Telstra Submission to ACMA Consultation: Review of the 850 MHz and 1800 MHz spectrum licence technical frameworks

Public submission

27 March, 2026

Figure 1: Options for unwanted emission limits for non-AAS transmitters

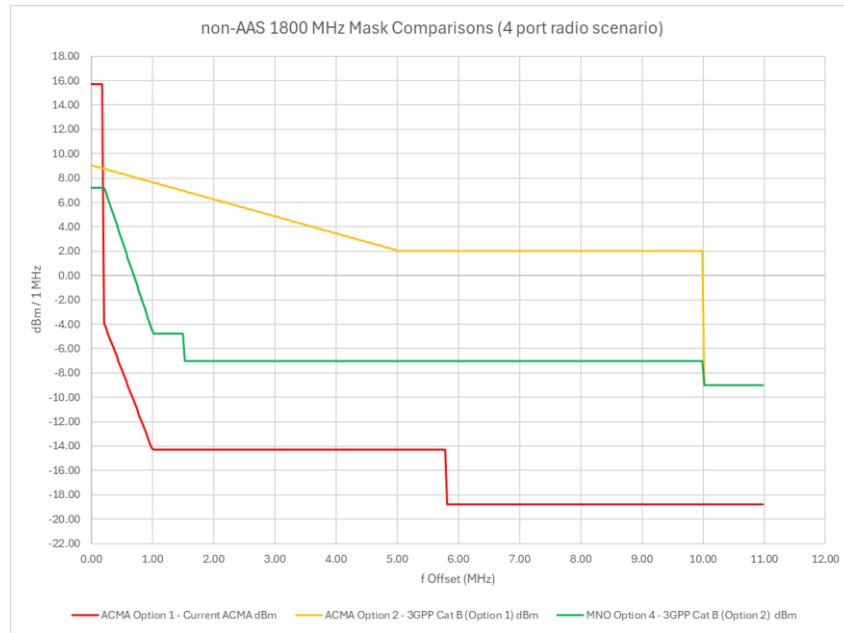
From this chart, it can firstly be seen that '3GPP Category B Option 2', has significant benefits (between 9 and 13dB) over the ACMA Option 2 '3GPP Category B Option 1' proposal in terms of adjacent channel unwanted emissions. It is acknowledged, however, that it is still an increase over the existing ACMA licence levels.

Figure 2: Options for unwanted emission limits for AAS transmitters

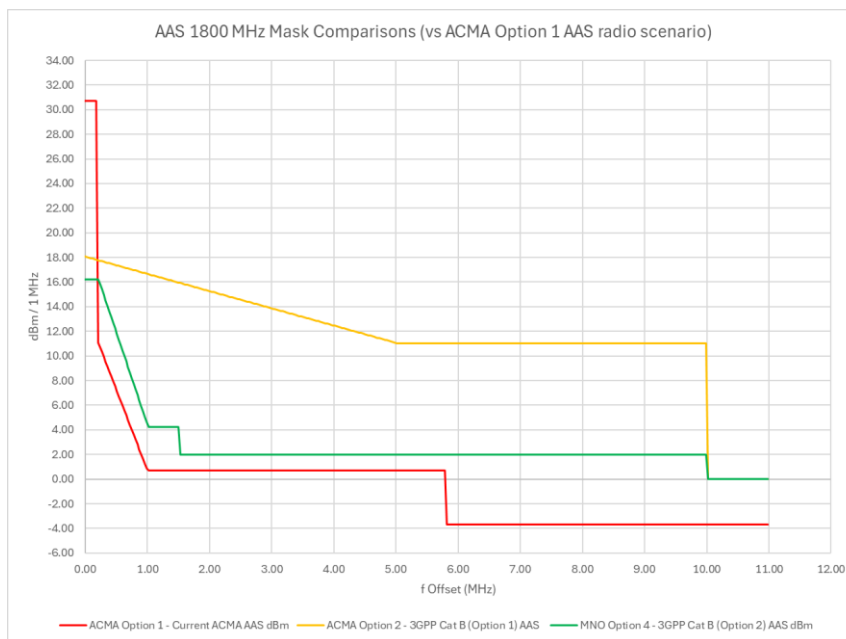
When comparing the results for AAS antenna solutions, the difference between the current ACMA limits and the proposed new AAS limits is much less. This is a result of us benchmarking the new proposed Cat B emissions against a 4 port non-AAS equivalent site. The good news with the AAS version is that the difference between the current and the proposed Category B Option 2 standards is relatively minor compared with Option 2 and 3 proposed by ACMA.
